## REQUEST

Current Zoning: R-3 (single family residential)  
Proposed Zoning: UR-2(CD) 5 year vested rights (urban residential, conditional, with 5 year vested rights)

## SUMMARY OF PETITION

## STAFF RECOMMENDATION

### • **Proposed Request Details**

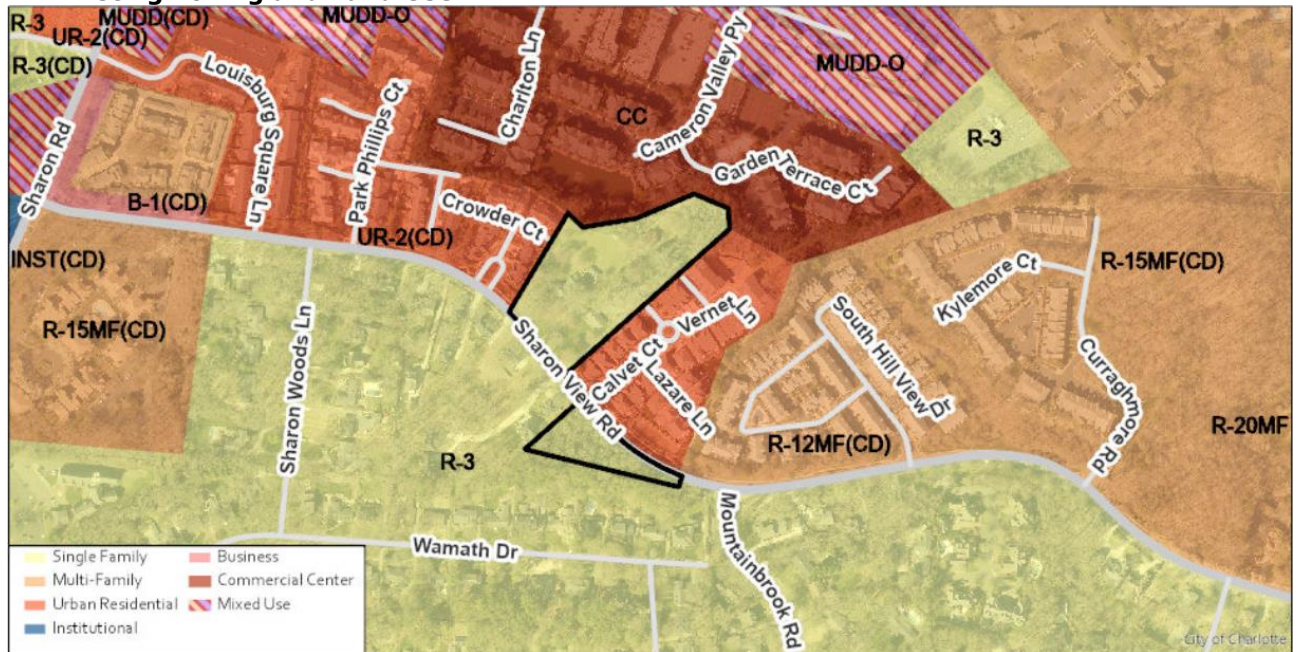
1. Amend the data table and setback line/label to increase the setback to 18 feet from the future back of curb to match the site plan drawing and to ensure buildings are setback similar to neighboring existing dwelling east of the site. Or add a commitment to the rezoning plan to provide entry/landscape areas along the site frontage between the back of sidewalk and the units similar to the neighboring existing development to the east.

2. Amend transportation note c. to say "The petitioner will construct a bicycle and pedestrian connection from Sharon View Road to the rear of the site."

3. Update Site Conditional Note, Transportation F, to state that a minimum of twenty feet (20') shall be maintained between driveways in accordance with the City of Charlotte Driveway Standards. Where practical, the petitioner should construct shared driveway access between the individual properties to help produce a more organized and pedestrian oriented form of access management in accordance with the City of Charlotte Driveway Regulations and Charlotte WALKS.

4. Remove the site conditional note for Transportation G.
5. Update the site conditional note for Transportation H as follows, "Per Chapter 19, the developer shall construct sidewalk and curb and gutter along the site's frontage along Sharon View Road. The City engineer will determine the future back of curb along public streets as planned for improvement by the City in accordance with Chapter 19-173 of the City's Ordinance."

6. Amend what is shown on the rezoning site plan drawing to ensure Fire access can be made to the 150-foot exterior of all buildings.
7. Clarify note 5 under Architectural Standards to explain how the commitment will be made or amend the site plan to show the walkways described.

8. Separate the Streetscape and Landscaping note so that one deals with the entrance feature/fencing and the other deals with the landscape easement area along the eastern property line.
9. Amend note 8 under Architectural Standards to remove the words "that adjoin single-family zoning." All buildings should be limited to 40 feet.
10. Remove requested 5-year vested rights from the petition.

11. Amend what is shown on the rezoning site plan drawing to ensure it is compliant with the Tree Ordinance.
12. Amend construction note 2 to replace the words "too narrow" with "less than 30' width."
13. Revise notes under Environmental Features section to include the two requested notes related to water quality treatment and volume and peak control on the north side of Sharon View Road and the note related to stormwater controls collection from all impervious surfaces to Sharon View Road system described on the Stormwater memo and as agreed upon in the 10/22 meeting with Storm Water Services staff.

14. Provide the following technical correction as reviewed by Planning and CDOT staff, revise Conditional Note D under Transportation as follows, "The Petitioner will extend the proposed 54-foot public right-of-way from the cul-de-sac to the northmost property line as generally depicted on the site plan."
  15. Reconcile the site plan callout with the revised Conditional Note for Transportation D.
  16. Label and dimension curb and gutter at 27-ft from the Sharon View Road centerline.
-
